VERIFICATION REPORT FOR PROGRAMME OF ACTIVITIES AND VOLUNTARY PROJECT ACTIVITIES (POA AND VPA(S))

GS ID of PoA and VPA included in the verification	GS1247 Improved Kitchen Regimes Multi-Country PoA (GS1247) Version 9 VPA 122 – GS 5951 VPA 123 – GS 5952 VPA 124 – GS 5953 VPA 125 – GS 5954 VPA 126 – GS 5955 VPA 129 - GS 6041 VPA 130 – GS 6042
Title of PoA and VPAs	VPA 122 – GS 5951 VPA 123 – GS 5952 VPA 124 – GS 5953 VPA 125 – GS 5954 VPA 126 – GS 5955 VPA 129 - GS 6041 VPA 130 – GS 6042 GS1247 VPA 122 Zoba Anseba Community Safe Water (GS5951) GS1247 VPA 123 Zoba Anseba Community Safe Water (GS5952) GS1247 VPA 124 Zoba Anseba Community Safe Water (GS5953) GS1247 VPA 125 Zoba Anseba Community Safe Water (GS5954)

GS1247 VPA 126 Zoba Anseba Community Safe Water (GS5955) GS1247 VPA 129 Zoba Anseba Community Safe Water (GS6041) GS1247 VPA 130 Zoba Anseba Community Safe Water (GS6042)	
Version number of the verification Report	02	
Completion Date of verification Report	02/10/2024	
Version number and completion date of the PoA-DD and VPA-DD to which this report applies	Version 2 (All VPAs)	
Date of listing	04/04/2018	
Coordinating and Managing Entity (CME) / Project Developer (PD)	Johanna

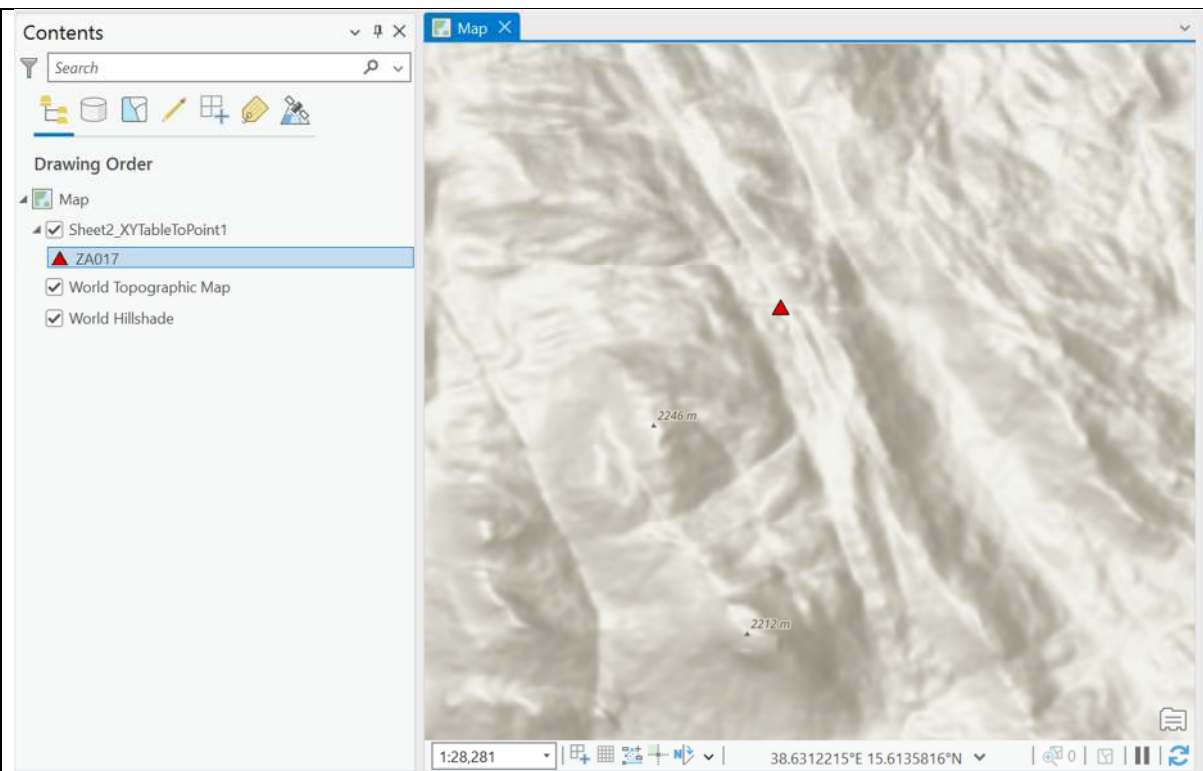
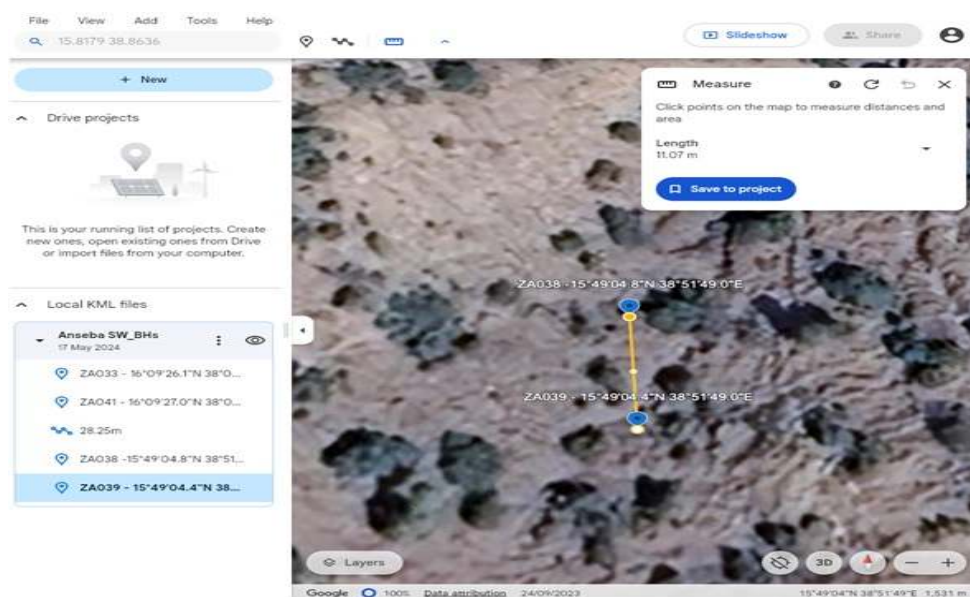
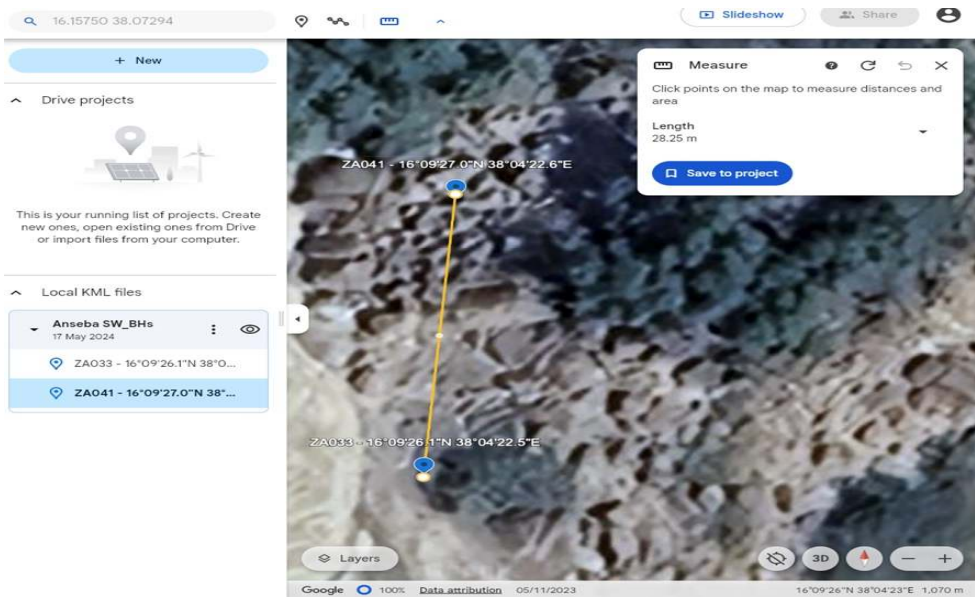
1. Accepted based on the supporting documents given. CLOSED
2. Accepted except for the claim that ZA0017 showing up in lake. PD is requested to clarify on the same, since poor connectivity reason can be used selectively. Since by that token, rest of the coordinates should also be faulty. OPEN
3. The coordinates in the MR when transposing in Google earth pro clearly show overlap. The evidence to that effect already given. Besides the coordinates differ from each other at between 0.0001 to 0.0025 at northing while in the easting coordinates they differ between 0.0000 to 0.0002. In other words in practical terms there is an overlap confirmed by google earth pro. PD is requested to ensure that all boreholes have unique coordinates. OPEN
4. Hence CAR is open.

2. PD would like to emphasize that the coordinates are not to be considered faulty but not highly accurate. Eritrea is dominated by extensions of Ethiopian north-south trending highlands, descending on the east to a coastal desert plain, on the northwest to hilly terrain and on the southwest to flat plains. The country has a high central plateau that varies from 1,800 to 3,000 meters, the area of BH ZA017 falls into this mountainous region and is found to be closely located near mountain peaks 2246m and 2212m (please see image for reference). According to Satomura, M. et al. (2005) GPS results in mountain areas are usually found to be less accurate than those in flat areas due to terrain obstructing satellite signals, which can reduce reception and thus accuracy of GPS navigation. Additionally, steep slopes can cause signal reflection and multi-path errors, further reducing the accuracy of GPS navigation.

However, PD has now removed BH ZA017 from the project, as in this case it has been found that it is not functional currently due to flooding, so as we cannot be certain to differentiate the borehole from the satellite imagery in the lake, we have decided to be conservative and remove it from the project. The ER's and MR have been updated to reflect this.

3. When plotting the coordinates of the above outlined BHs on Google earth as per suggestion of the VVB, it is evident that these are not directly overlapping. In the case of ZA033 and ZA041, a distance of 28.25m is found between the respective BHs, whilst in the case of ZA038 and ZA039 a distance of 11m is seen (please see pictures for reference). These BHs can thus be said to both be found in the same village however are not to be said to be overlapping. Furthermore, PD has received confirmation that the WRD has checked the locations of the boreholes and independently confirmed that they are very close together, with distances comparable to those found using Google Earth.
